Subject: Reply to Information Requested at Public Meeting between RG&E and NRC Staff
Held on August 19, 2003.
R.E. Ginna Nuclear Power Plant
Docket No. 50-244

References: 1. Letter from Robert C. Mecredy (RG&E) to Robert L. Clark (NRC) dated May 21, 2003, License Amendment Request Regarding Revision of Ginna Technical Specification Sections 1.1, 3.3.6, 3.4.16, 3.6.6, 3.7.9, 5.5.10, 5.5.16, and 5.6.7 Resulting From Modification of the Control Room Emergency Air Treatment System and Change in Dose Calculation Methodology to Alternate Source Term.

Verification of Commitment Resolution

Alternative Source Term and Control Room Emergency
Ventilation System Submittal

FIGURE 5.1 - AIRBORNE FRACTION

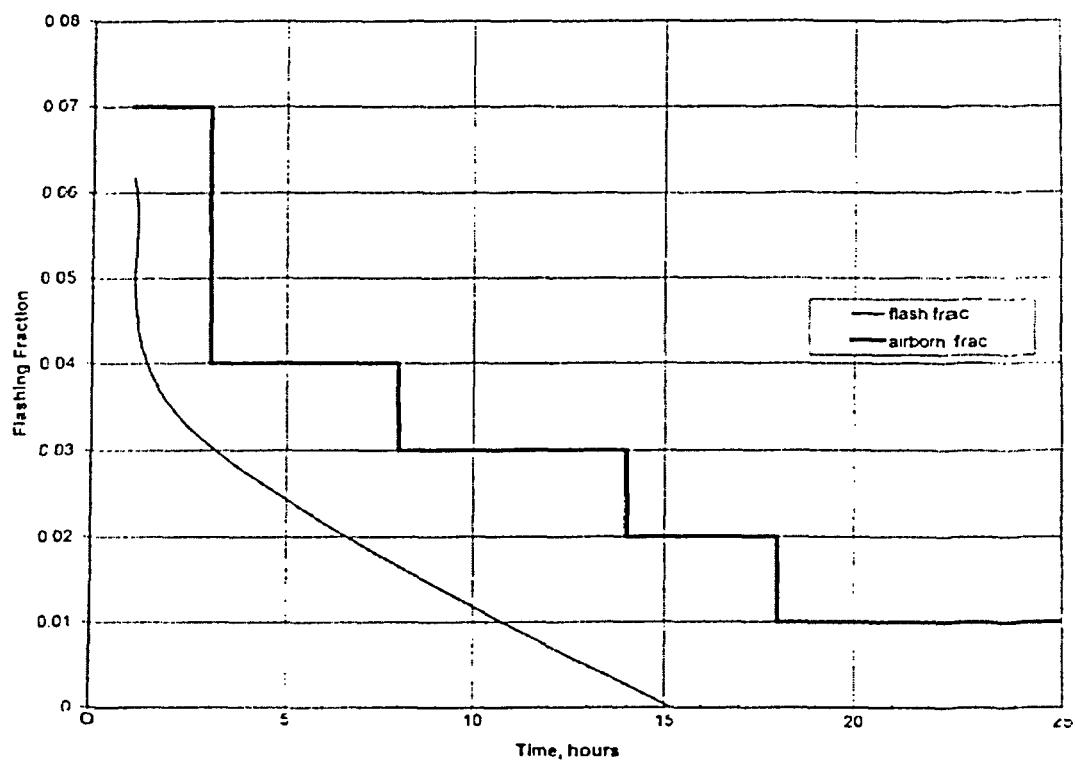
1. NRC would prefer that RG&E use 2% versus 1% iodine partitioning for beyond 18 hours of Emergency Core Cooling System (ECCS) leakage.

Resolution: The Loss of Coolant Accident (LOCA) dose analysis was revised to reflect the above and to incorporate the new X/Q values for the Exclusion Area Boundary (EAB) and Low Population Zone (LPZ). The Summary of Radiological Analysis (Attachment 2) was revised to reflect the new analysis.

Note: Due to NRC comments during the review process, the assumed flashing fraction was increased to 0.02 for $T > 18$ hours.
